**STAFF REPORT ADDENDUM #2**

**RZ 2014-MA-011 / SE 2014-MA-013**

# CRD

**CONCEPTUAL LANDSCAPE PLAN**  
**THE SHOPS AT BAILEY'S CROSSROADS**

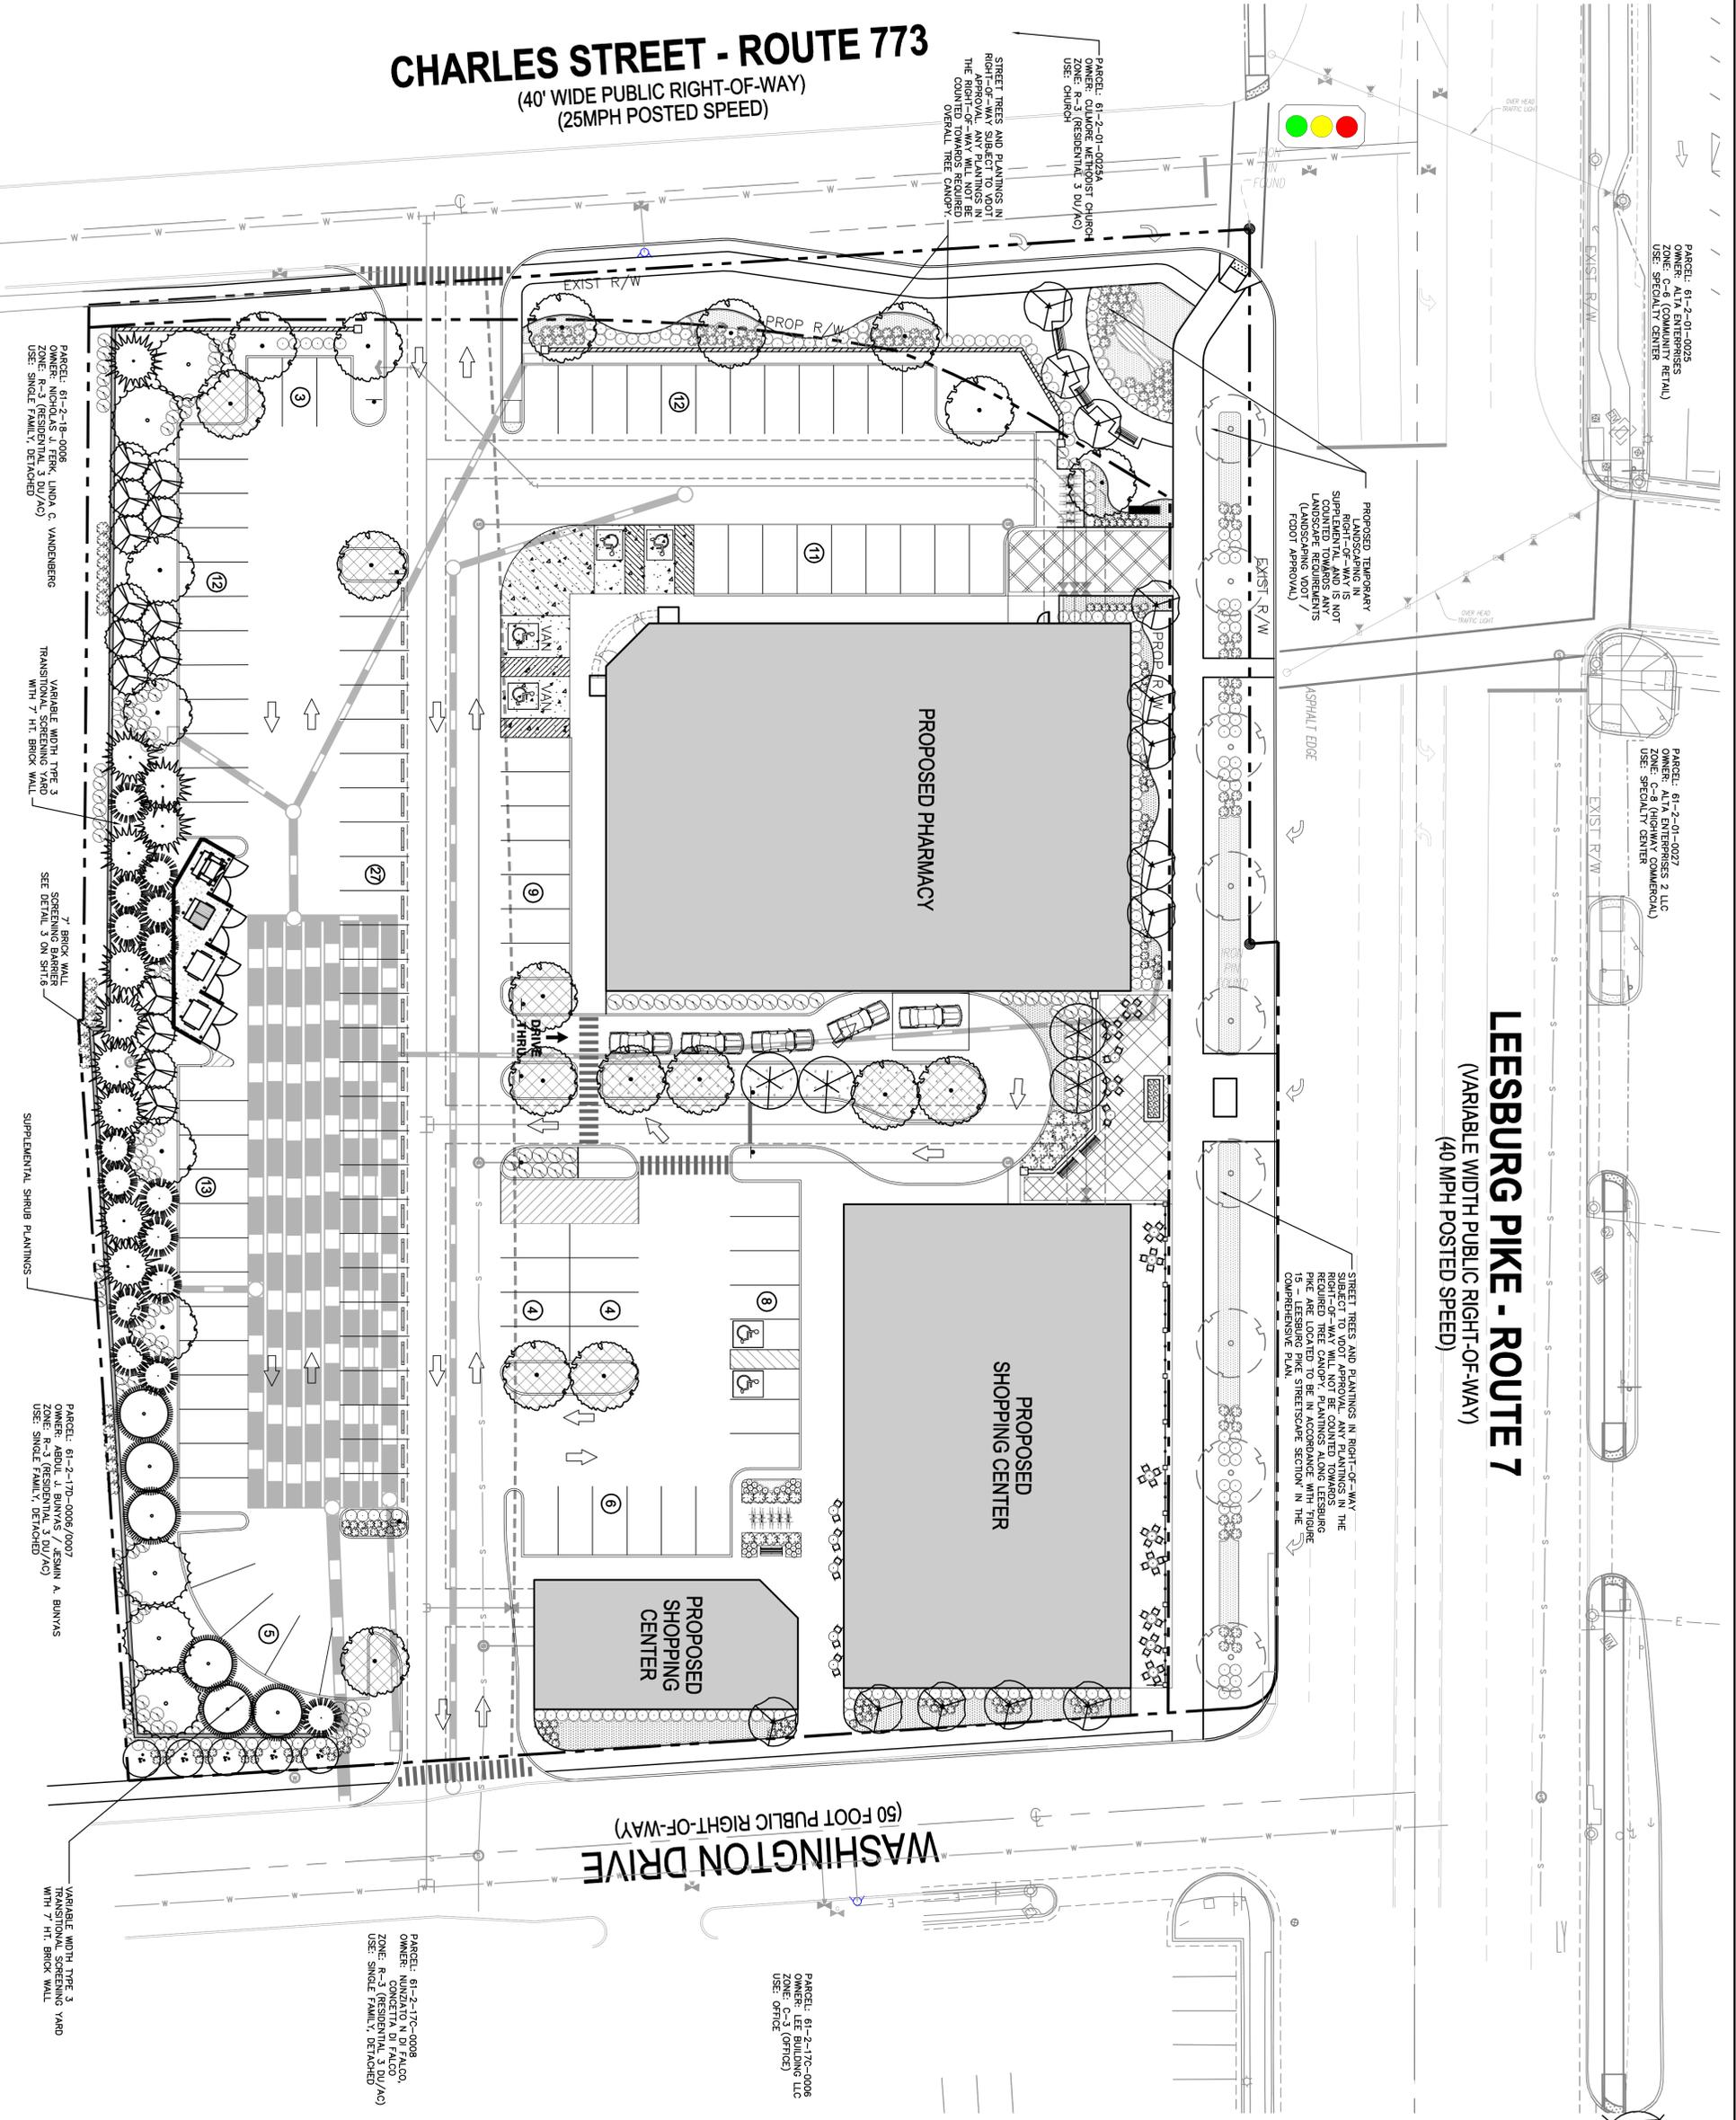
- The Landscape Plan (Sheet 4) should note that trees will be spaced widely enough apart to frame the entry plaza and bus shelter at the mid-block location under interim and ultimate built conditions.

- On the Landscape Plan (Sheet 4), pedestrian-style lights should be shown to be located in places along the streetscape that do not conflict with street trees at their projected maturity.

- Consideration should be given to installing special pavers for this outdoor seating area (Landscape Plan Sheet 4), and to adding this area to the Landscape Amenity Areas & Perspectives (Sheet 7) to provide greater design detail. The special pavers should be similar to or complimentary to the pavers in the main entry plaza, to help define the space.

**CHARLES STREET CONCEPTUAL ALIGNMENTS  
THE SHOPS AT BAILEY'S CROSSROADS**

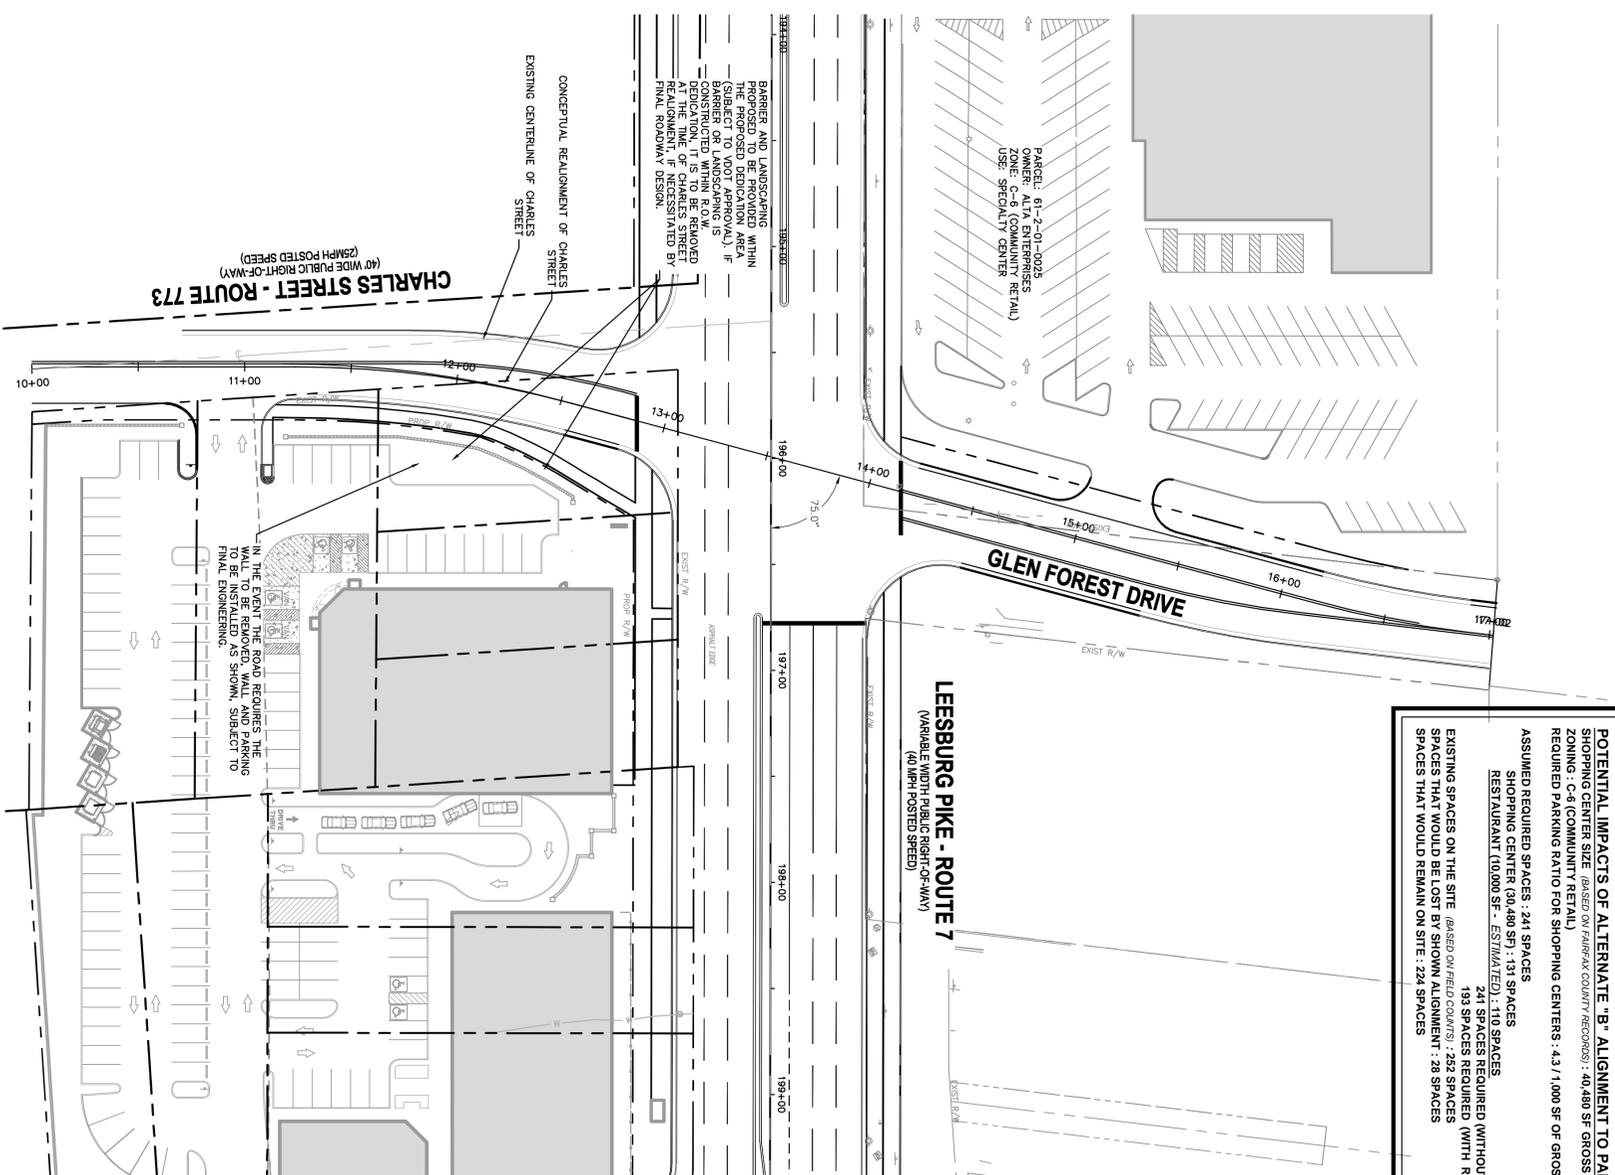
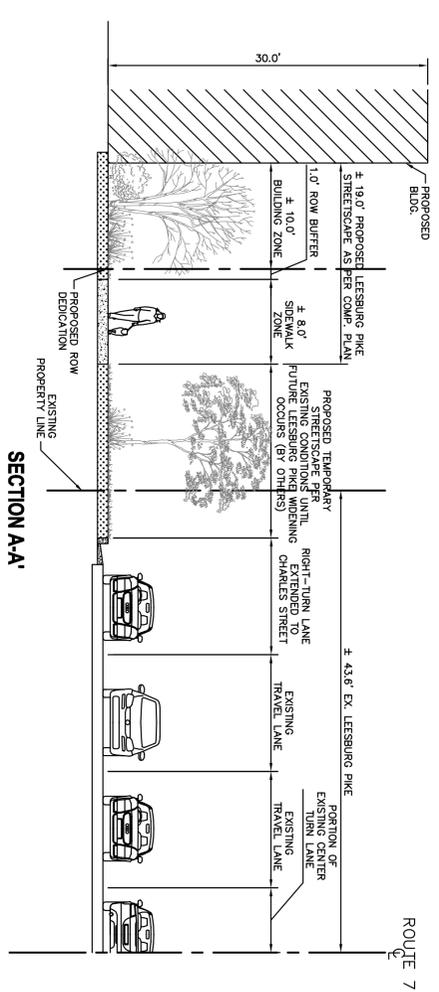
As discussed in the Staff Report and the first Addendum, the proposed right-of-way dedication along Charles Street does not provide for a safe realignment of Charles Street with Glen Forest Drive, as recommended by the Comprehensive Plan. As before, the proposed dedication area would result in a 67-degree angled approach, where the maximum recommended would be 75 to 80 degrees.

**Charles Street Streetscape.** The Charles Street Conceptual Alignments (Sheet 5) should be revised to reflect landscaping on the portion of the site converted from parking to landscape area following construction of the Charles Street alignment (see photo 2, photo 3 in Streetscape & Plaza Concept attachment). The portion of the site converted from parking to landscape area after construction of the road should be planted in a manner that is consistent with the rest of the shopping center landscaping. A note on Sheet 5 could also accomplish this.

1 LEESBURG PIKE - PROPOSED CONDITION AFTER THE SHOPS AT BAILEY'S CROSSROADS' DEVELOPMENT  
 SCALE: 1/8" = 1'-0"

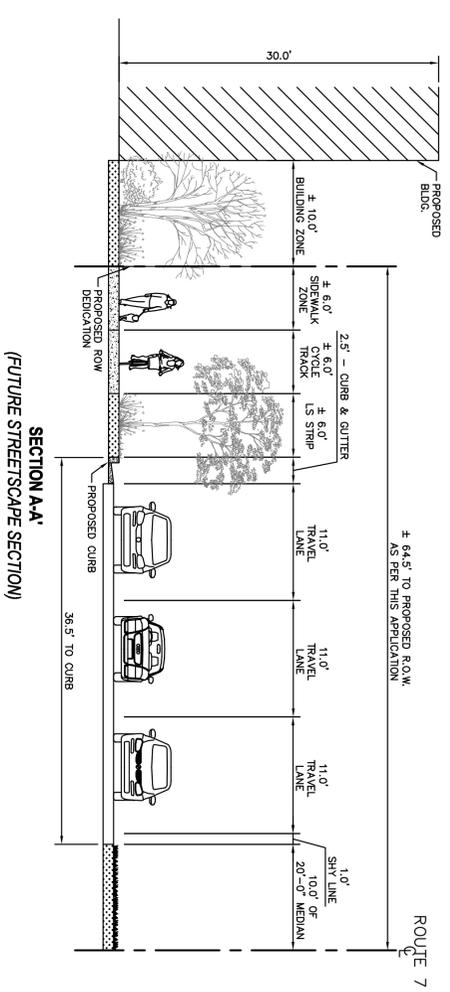
- o Update the Street Sections (Sheet 5A) #1 Leesburg Pike Proposed Condition After Shops Development section to reflect all dimensions for the interim streetscape layout. These dimensions should include the building zone, sidewalk, interim landscape strip (for a future bike lane), (tree) landscape strip, and interim landscape strip (for future road

- o Notes on the GDP (Sheet 3), Landscape Plan (Sheet 4), and labeling on the Street Sections (Sheet 5A) #1 Leesburg Pike Proposed Condition After Shops Development section, should indicate that the street trees will be planted in the ultimate planting location during the interim so that the trees do not have to be removed if/when the ultimate streetscape layout is implemented.

- The Street Sections (Sheet 5A) should also show a close-up plan view of the Leesburg Pike Streetscape with the mid-block bus shelter and the main entry plaza area if the bike lane is installed in the future under the ultimate-future road widening conditions. This layout should demonstrate how pedestrians and bicyclists will be able to navigate around the bus shelter and interact with the plaza in the building zone area under the more constrained streetscape conditions. A previous August 3, 2015, submission provided this view under #3 Leesburg Pike Alternative (with cycle track) Plan; the image should be reinserted and updated with the mid-block bus location (see Photo 1).

- While the Street Sections (Sheet 5A) reflect the two streetscape layouts (interim and ultimate – future road widening conditions) along Leesburg Pike from a section view, the sheet should also show the two layouts from the plan view given the complex nature of the site as it transitions from interim to ultimate (see Streetscape & Plaza Concept Attachment for an example of the two plan views).

**Pedestrian-Style Street Lighting.** (Sheet 5A). Details should be provided of the pedestrian-style light fixture in terms of style, type, intensity and general location.

- Sheet 5A does not provide sufficient detail regarding the lighting proposed. It is unclear in which contexts the lights shown would be used (e.g., in the parking lot? Mounted to a building? Along the roadway?). Sheet 5A lighting examples should be labeled with their intended uses/locations, and a full-length picture of the pedestrian-style street lighting proposed should be provided.

- The dumpsters have been shifted away from adjoining dwellings to a central location along the rear.
- Section 2 on Sheet 5A has been revised to show the cycle track between the sidewalk and landscape strip as recommended by staff.

Photo 4 - Plaza

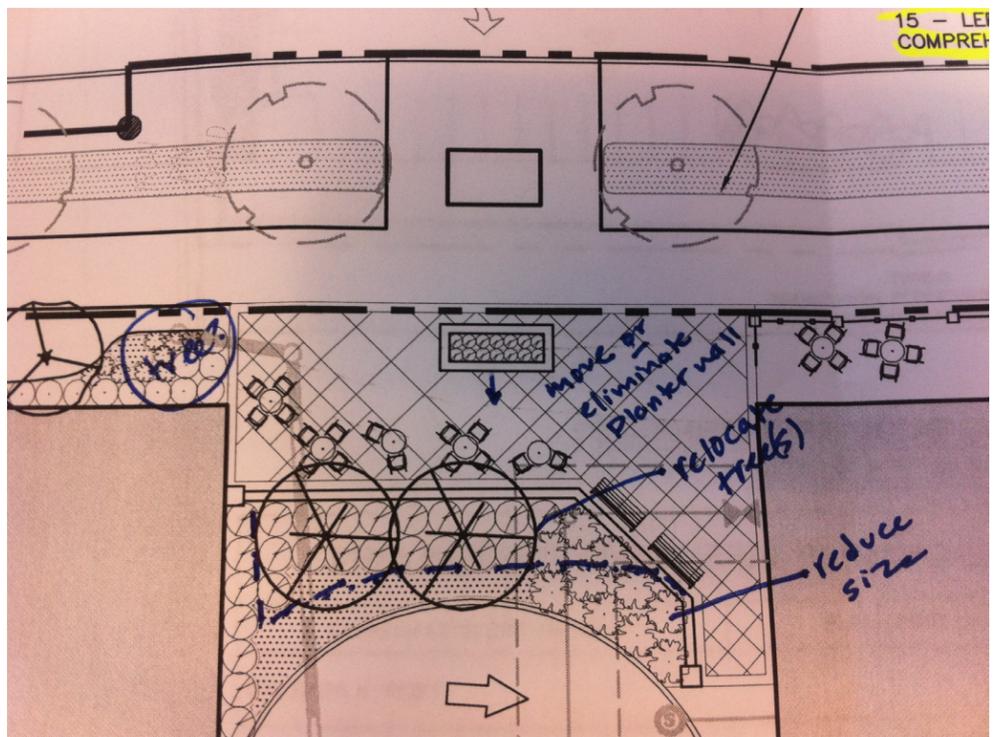
- o If the planter landscaping area is reduced, consideration should be given to relocating one, or both of the Category III deciduous trees proposed in the main entry plaza to another part of the site and replacing the tree(s) with a variety of shrubs, grasses and flowers for screening given the reduced space. Consideration should also be given to installing shade sails over the plaza for cover and visual interest (see Streetscape & Plaza Concept Attachment for an example of the plaza layout with a reduced planter landscaping area and use of shade sails; also see Photo 4).
